Access Compliance Report

Public Rights-of-Way

(Curb Ramps)

Intersection ID: 12521	Main Street: BELVEDERE_AV	Cross Street: CHATHAM_AV	Location: NE
ADA ID: 32DE3A0A160D	Ramp Type: PerpDiag	Initial Pass/Fail: Pass	Overall Compliance: No
		Severity Score: 10

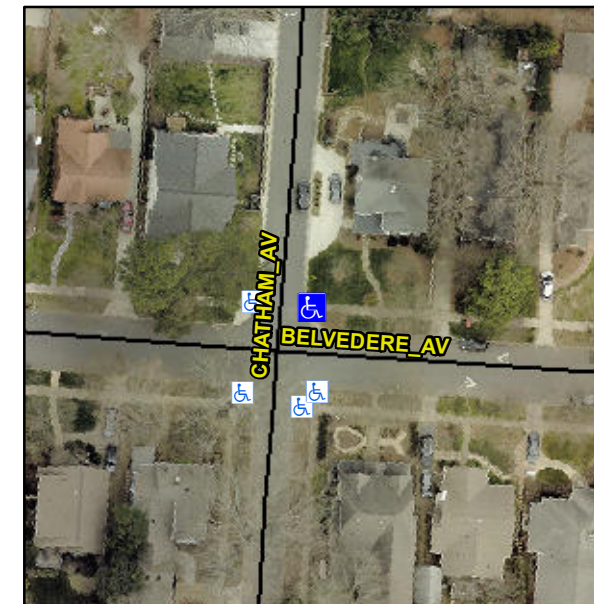
Not Found, R304.5.3, R305

Compliance	Description	Data	Compliance	Description	Data
N/A	Ramp Length (in)	52.0	Yes	Ramp Slope (%)	7.7
Yes	Ramp Width (in)	52.0	Yes	Ramp XSlope (%)	0.7
N/A	Flare Type LT	Sloped	N/A	Flare Type RT	N/A
N/A	Flare Slope LT (%)	4.4	N/A	Flare Slope RT (%)	2.8
N/A	Flare Traversable LT?	No	N/A	Flare Traversable RT?	No
Yes	Landing Length (in)	60.0	No	DWS Provided?	No
Yes	Landing Width (in)	59.0	N/A	DWS Contrast?	No
Yes	Landing Slope (%)	1.6	N/A	DWS Length (in)	N/A
No	Landing X Slope (%)	3.2	N/A	DWS Full Width?	No
N/A	Landing Curb? (Y/N)	No	N/A	DWS Offset (in)	N/A
N/A	Shared Landing?	Yes			
Yes	Gutter Ponding?	No	Yes	Gutter Slope (%)	3.6
Yes	Gutter Lip Ht (in)	0.0	No	Gutter X Slope (%)	3.1
N/A	Painted X Walk1?	No	N/A	Painted X Walk2?	No
	X Walk 1 Direction	To W		X Walk 2 Direction	To S
N/A	X Walk 1 Width (in)	N/A	N/A	X Walk 2 Width (in)	N/A
	X Walk 1 Slope (%)	3.0		X Walk 2 Slope (%)	2.5
	X Walk 1 X Slope (%)	1.7		X Walk 2 X Slope (%)	4.5

Remove & Replace Curb Ramp With Two New Directional Ramps or Equivalent. Remove & Replace Gutter.
